Subject: FINAL DANGEROUS AND/OR MIXED WASTE RESEARCH, DEVELOPMENT, AND DEMONSTRATION PERMIT FOR THE DEMONSTRATION BULK VITRIFICATION FACILITY: DESIGN - AGREED TO REVISIONS FOR SECONDARY WASTE AND WASTE DRYER SYSTEM DESIGNS

FINAL DANGEROUS AND/OR MIXED WASTE RESEARCH, DEVELOPMENT, AND DEMONSTRATION PERMIT FOR THE DEMONSTRATION BULK VITRIFICATION FACILITY: DESIGN – AGREED TO REVISIONS FOR SECONDARY WASTE AND WASTE DRYER SYSTEM DESIGNS

REVIEW COMMENT RECORD (RCR)

1. **Drawing F-145579-33-A-0100, Rev N, "Bulk Vitrification Waste Dryer P&ID"**
2. **Drawing F-145579-33-A-0101, Rev M, "Bulk Vitrification Waste Dryer Vacuum P&ID"**

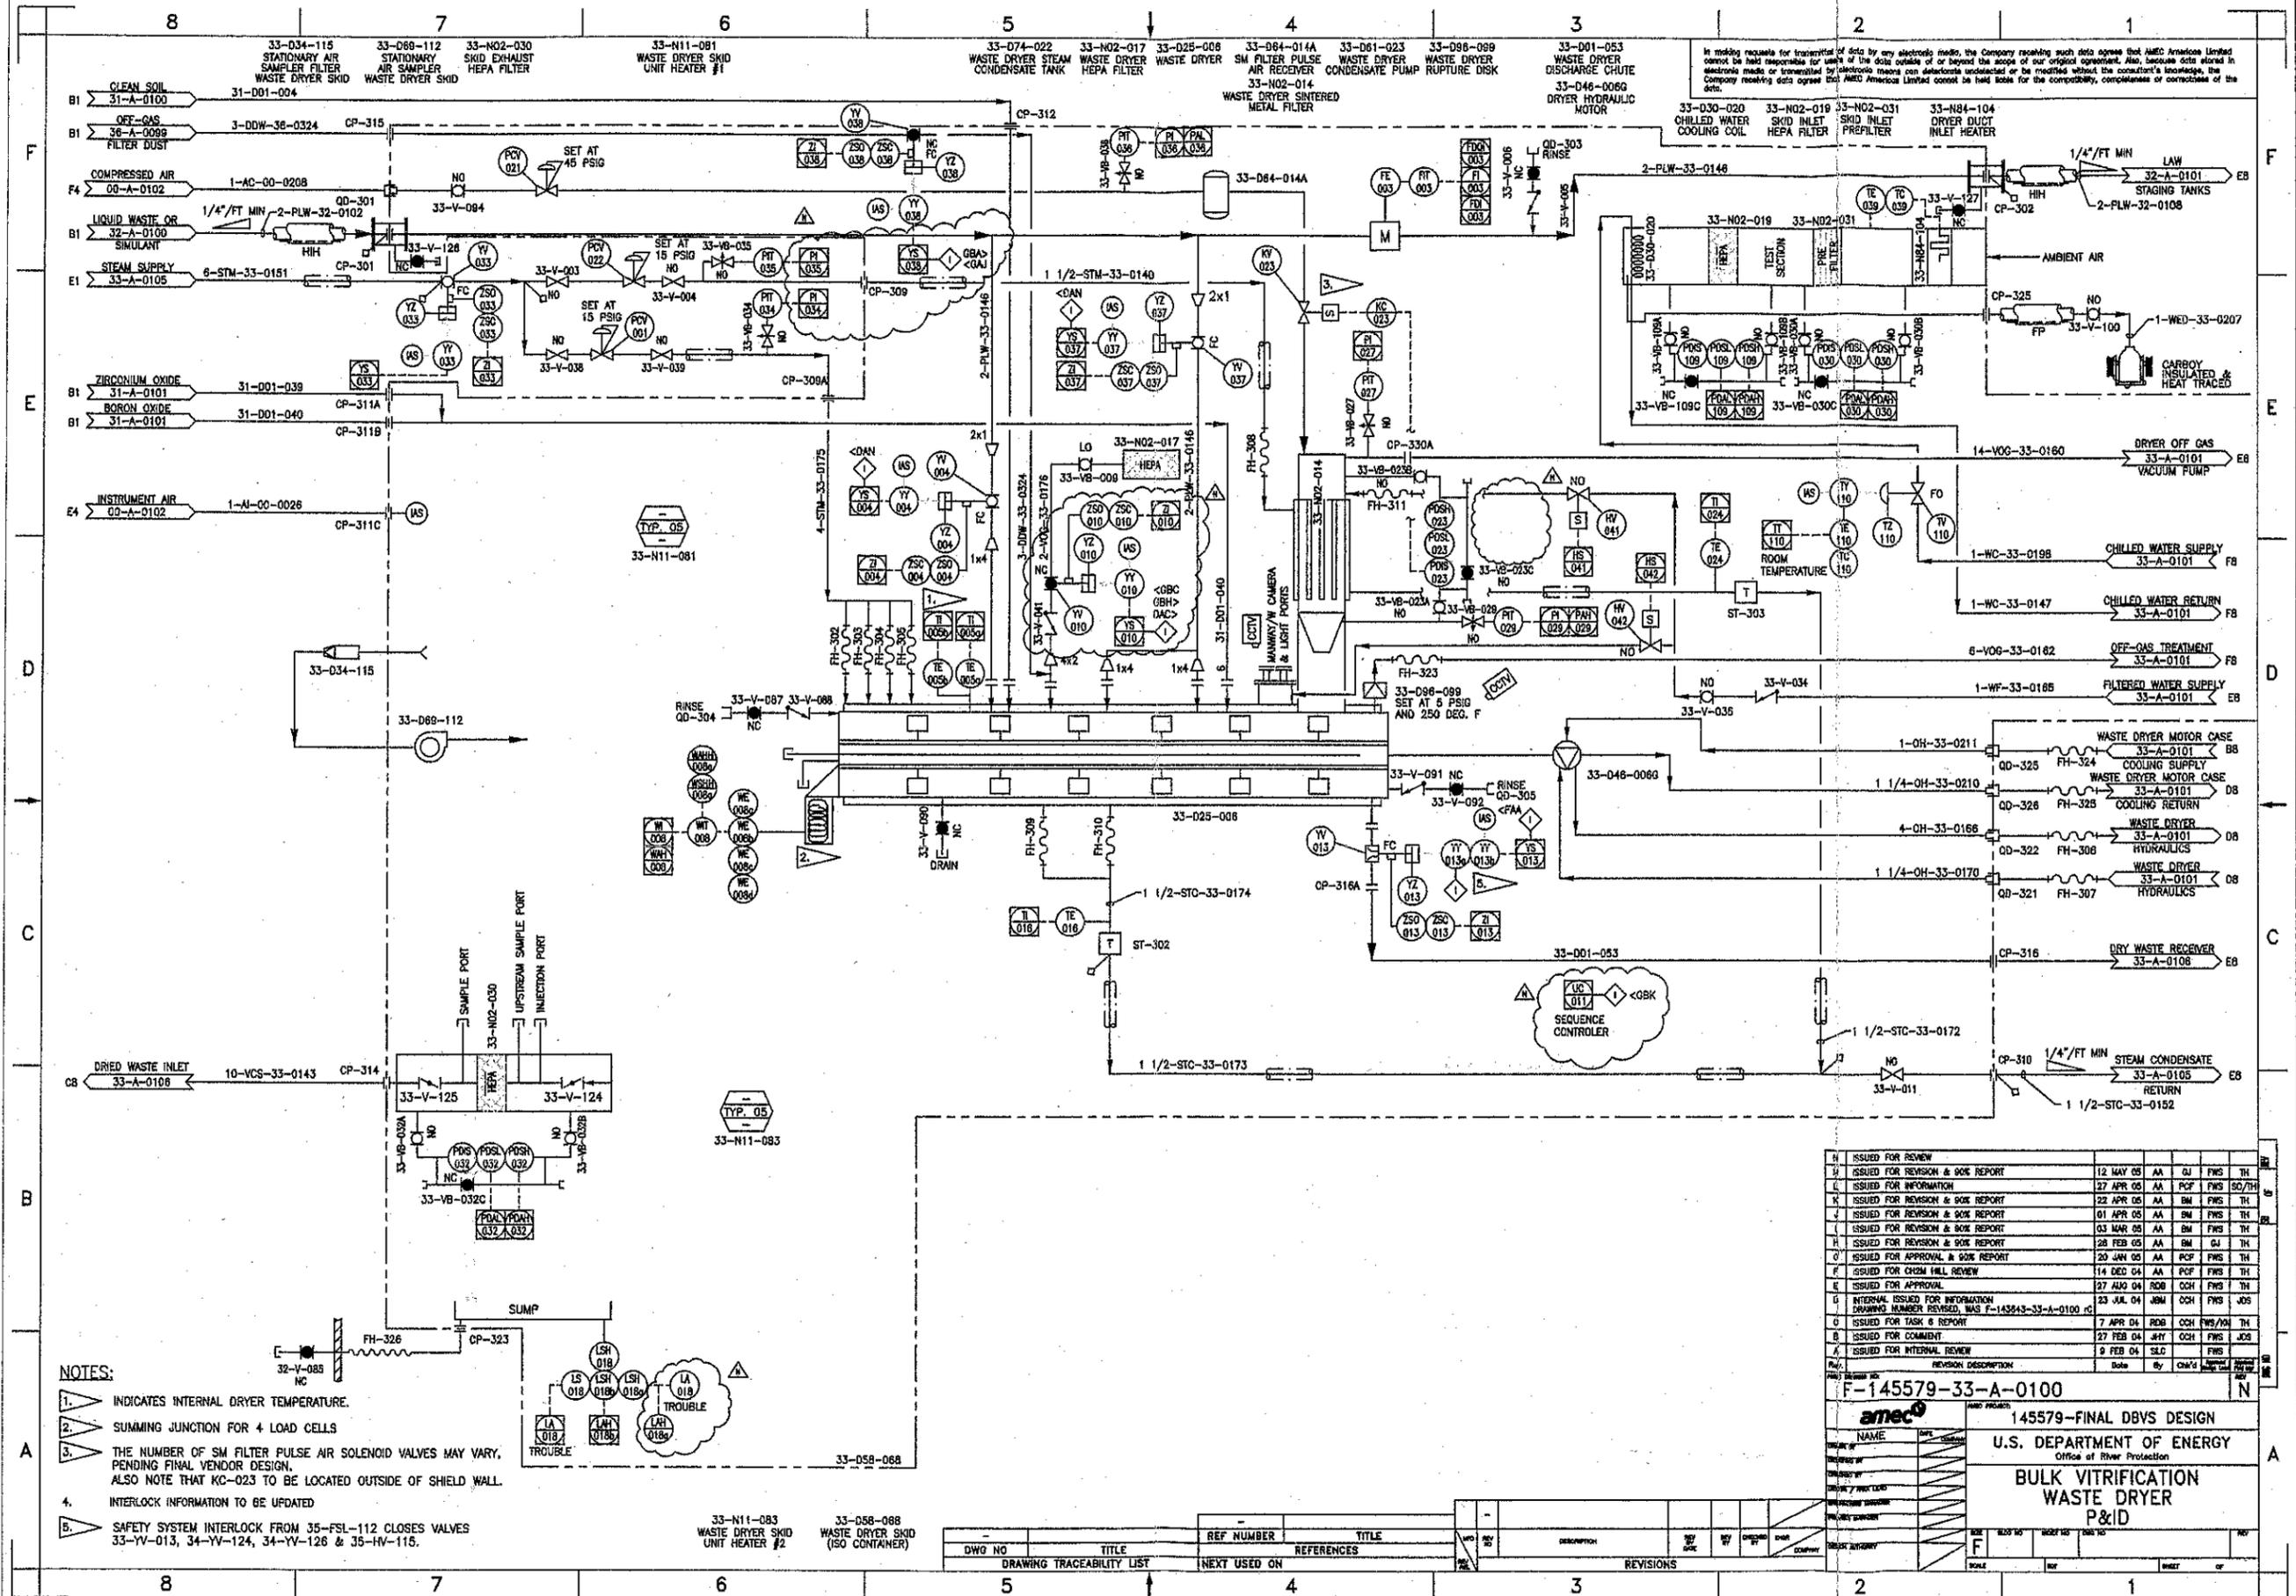
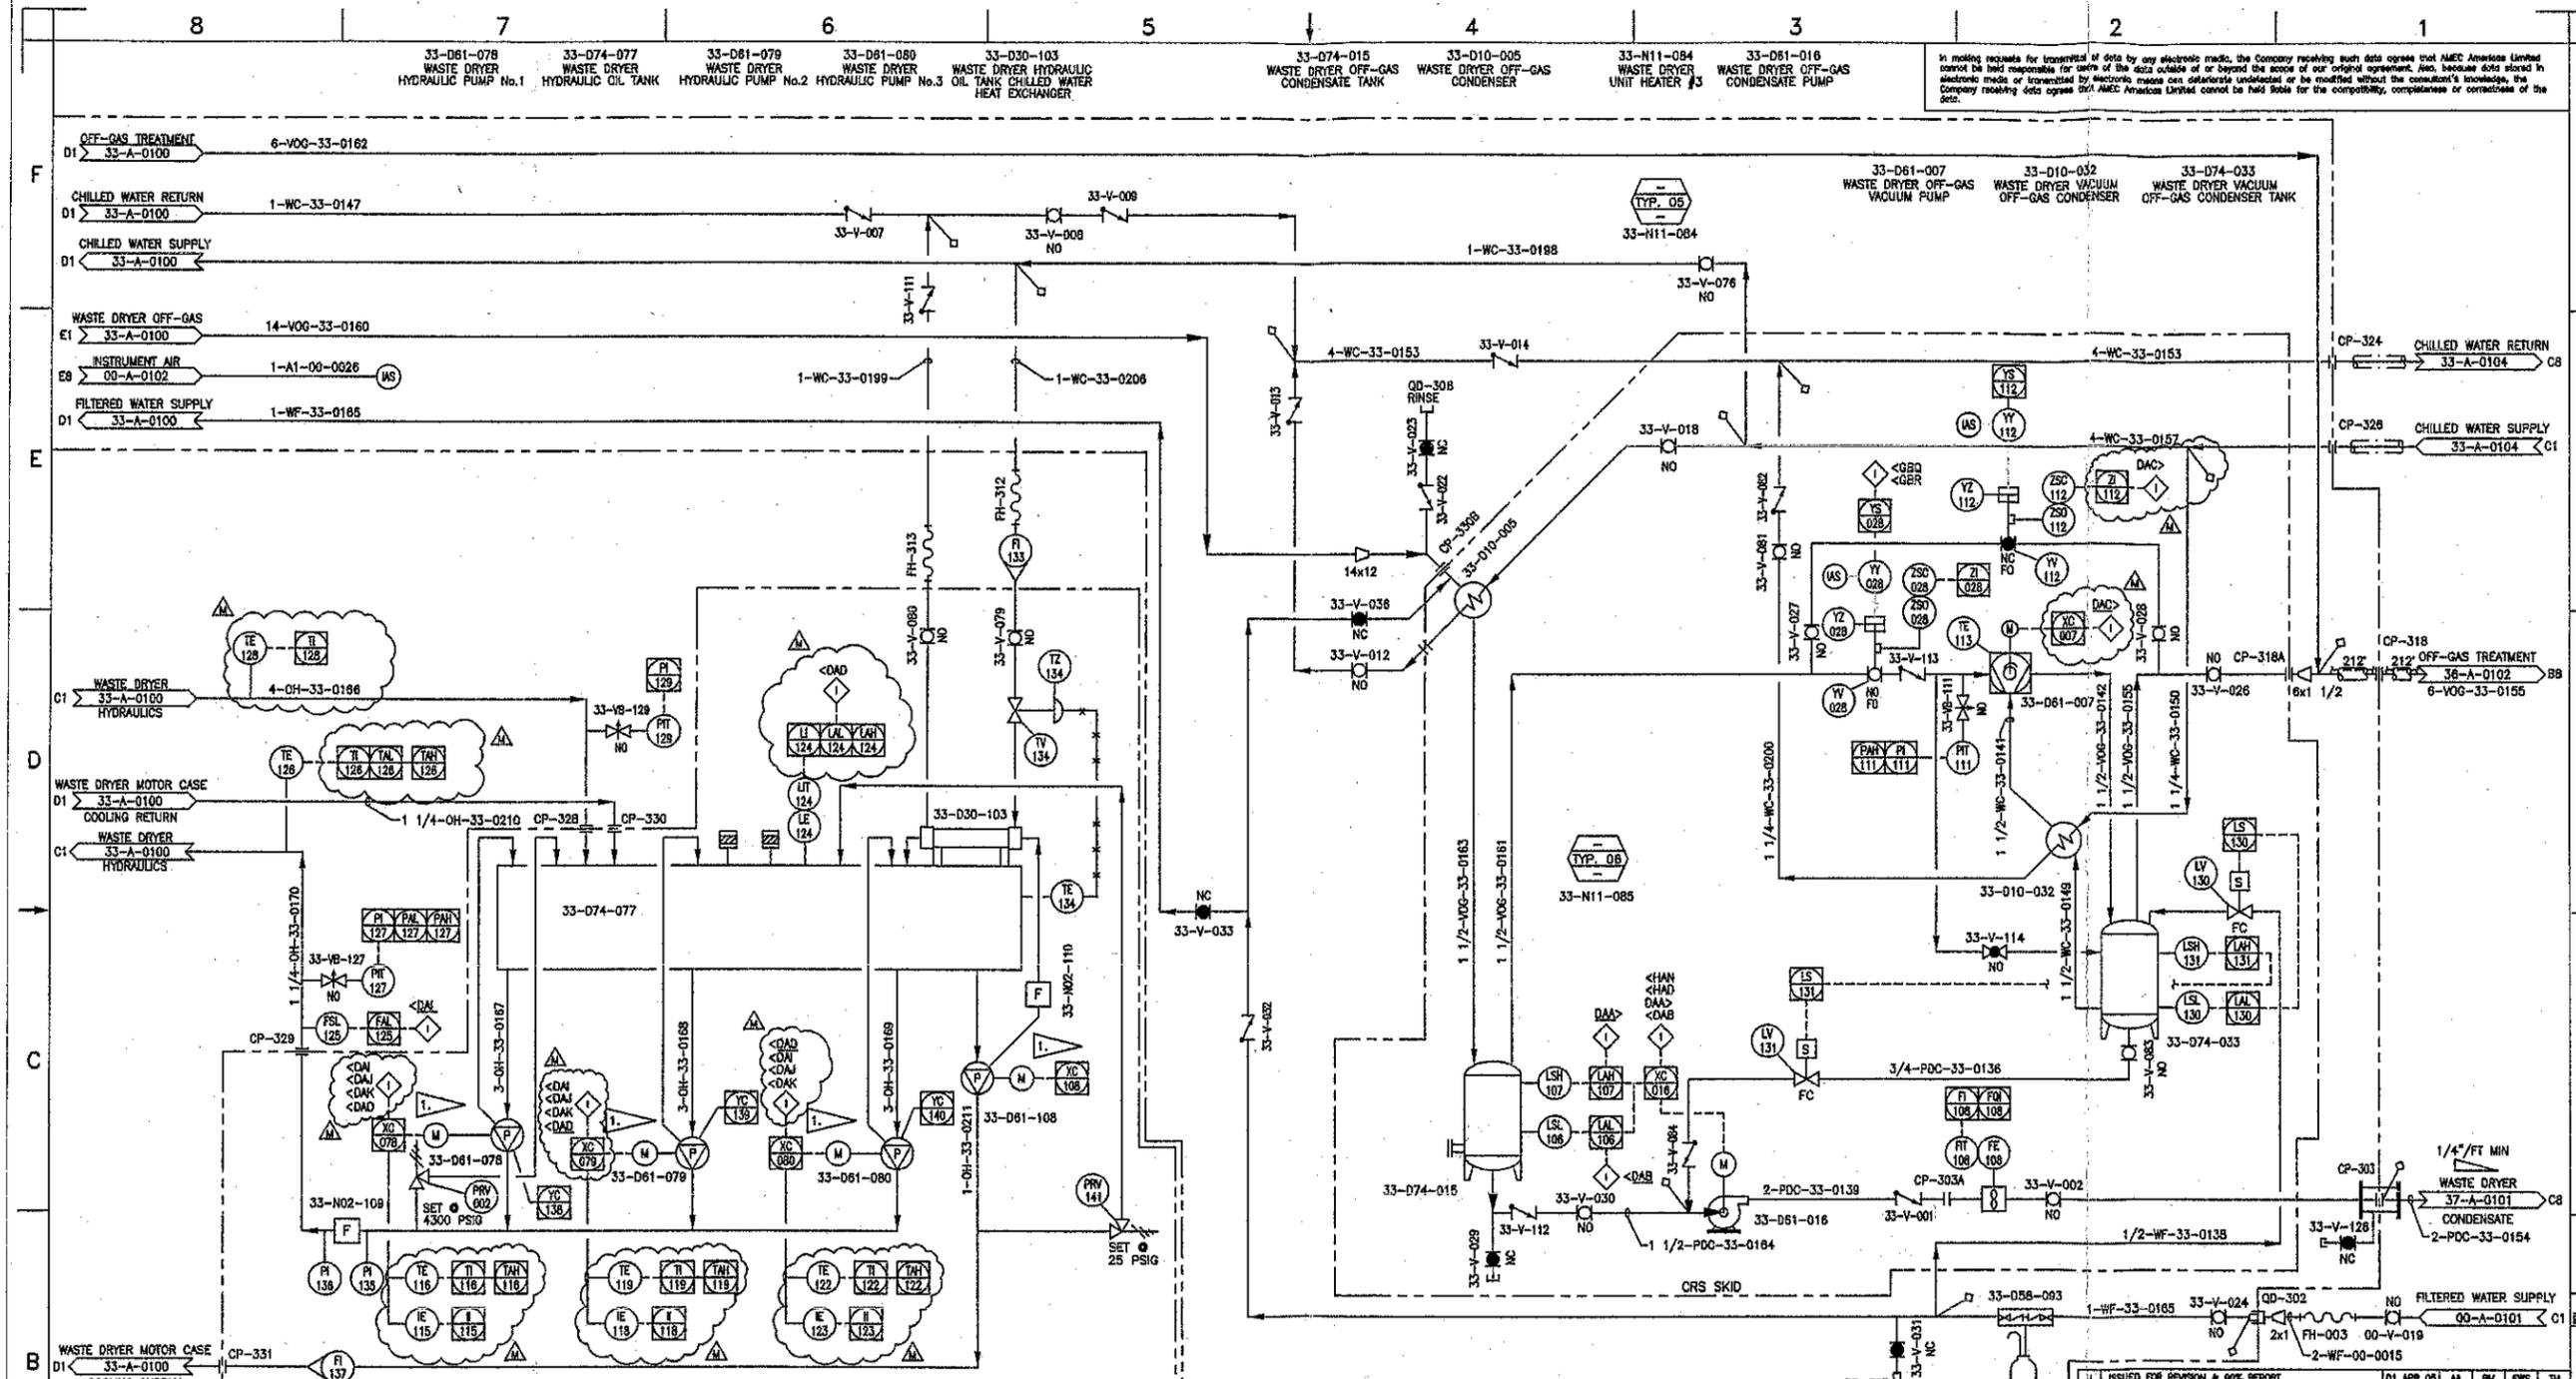
20.	<p>Is there a viewing window/sight glass or camera in the dryer that is already on site and is planned to be used [P&ID145579-33-A-0100 (D4)]; if so, what is the visibility range? Is the discharge port visible by these means? This feature would be useful in the event the discharge port area plugs up.</p> <p>Is there a sight glass on the wall of the dryer? Please provide information on the CCTV when available.</p>		<p>CCTV is planned for Dryer ISO container. Vendor info on the camera has not yet been received.</p> <p>Plugging of the discharge port will not necessarily be viewable from the outside of the dryer. Plugging will be avoided via continuous agitation of the dryer product while emptying the dryer.</p> <p>Sight glass and light port are located on top of manway. View of discharge port may be partially shielded / shadowed by 14"</p>	Closed

28.	p. G2-26 item d.; text indicates four ports for liquid waste charging. P&ID # F-145579-32-A-0100 (D4-D5) shows only three ports. Confirm if the dryer that will be used meets the specifications in 3.3.1.1		Correct. Three 4" ports are being used for liquid waste discharge into the dryer. The other 4" port is being used for SMF dust recycle to the dryer. This configuration will adequately distribute liquid waste throughout the chamber in the dry-batch operational mode and allow for SMF dust recycle to the dryer. Spec change warranted on next logical revision of spec.	Closed

35.	<p>p. G2-433 Table 3-1, the Rupture Disk "Maximum Normal Condition" is given as 5 psig. The Dwg 145579-33-A-0100 specifies that the rupture disk is set at 5 psig. It would appear that there should be an alarm (for operator intervention) at the maximum normal pressure and the disk rupturing point should be specified as being higher than the alarm point. Also, since the "normal" operating dryer pressure is 26" vacuum, will the rupture disk be sound at this negative pressure?</p> <p>For disposition refer to comment #2 in the companion RCR of the Dryer Design Package (both comments are similar).</p>		<p>33-PAH-029 provides the capability to alarm at less than 5 psig (see Zone D3).</p> <p>See p. G2-590 for rupture disk data sheet. Vacuum pressure specified at -26 in. Hg @ 250 deg. Rupture disks that provide positive 5 psi protection for vessels that operate at vacuum are available—see for example Fike Corp.</p> <p>Note that the mixer-dryer is never intended to operate at a pressure above atmospheric. The purpose of the rupture disc is to protect the dryer shell in the event of a leak from the steam jacket (15 psig/250 F) into the dryer. The dryer temperature & pressure is monitored and alarmed and provides a rapid response to this condition. If the steam leak is small, the dryer vacuum pump may have enough capacity to prevent a noticeable increase in pressure. If it is large, then the over-pressure condition will happen to rapidly for the operators to respond. The rupture disk is directional – i.e. it is rated for 5 psig in a certain direction only.</p> <p>See comment #2 on companion RCR</p>	Closed
